SYSTEM: Aux Building H & V

TML UNIT NO. 2
BURNS AND ROE, INC.
ENGINEERING CHANGE MEMO
(REV 12/75)

SERIAL NO. S-5915 RL
DISCIPLINE HVAC/ELECT
SUBJECT A.B. & F.H. - BYPASS DAMPERS

SERIAL NO. 55915 Rev. 1
 DISCIPLINE HVAC/ELECT.
 SUBJECT D4020A, 5683, 5890
 ATTACHMENTS 6

DWG 2343 R 18

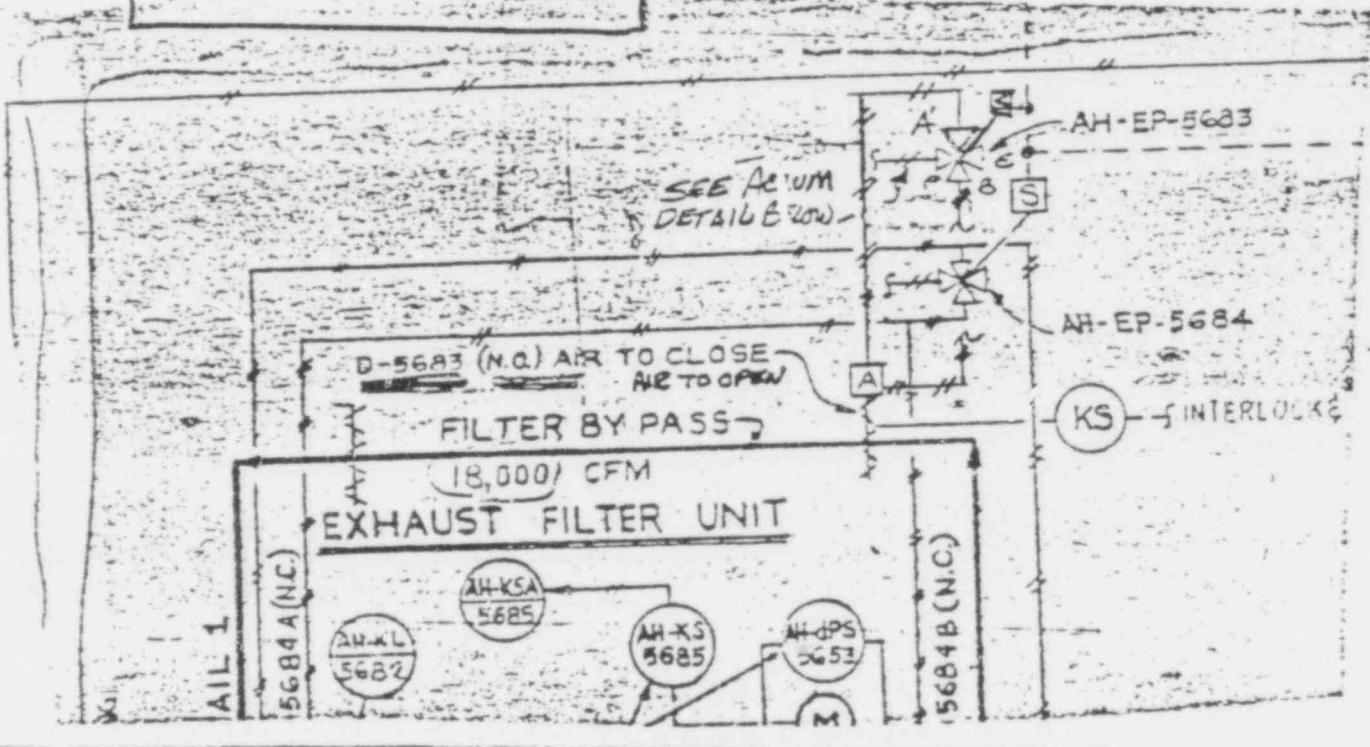
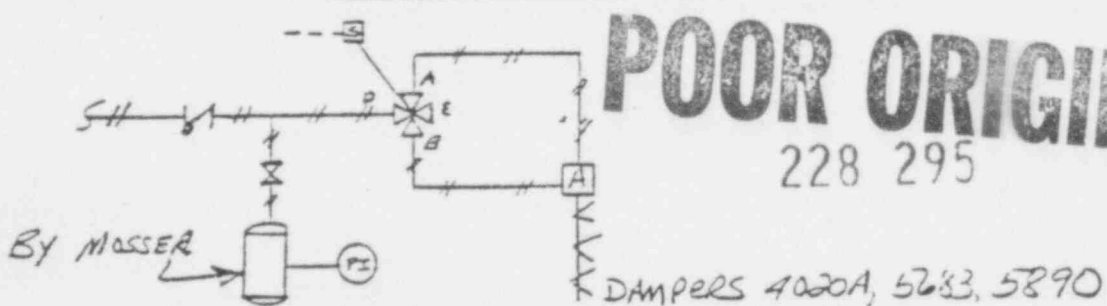
THE NEW DAMPERS ARE TO BE INSTALLED AS SHOWN ON ATTACH'S 576 & 2230 & 2231. B&R TO REVISE 2042, 2343, & B&R INSTRU. LIST AS SHOWN ON ATTACH'S 546. THE 'B' PORT OF SOLENOID VALVES AH-EP-5290, 5890, & 5683 IS TO BE UNPLUGGED TO PIPE UP THE NEW ARRANGEMENT SINCE THE DAMPERS ARE AIR-TO-OPEN / AIR-TO-CLOSE. THE SOLENOID & ACCUATOR ARE TO BE ARRANGED SO ENERGIZING THE SOLENOID OPENS THE DAMPER. THE CABLES ARE TO BE RESTORED TO THEIR ORIGINAL CONDITION PRIOR TO RELO TO THIS ECM.

DETAIL FOR ACCUMULATOR
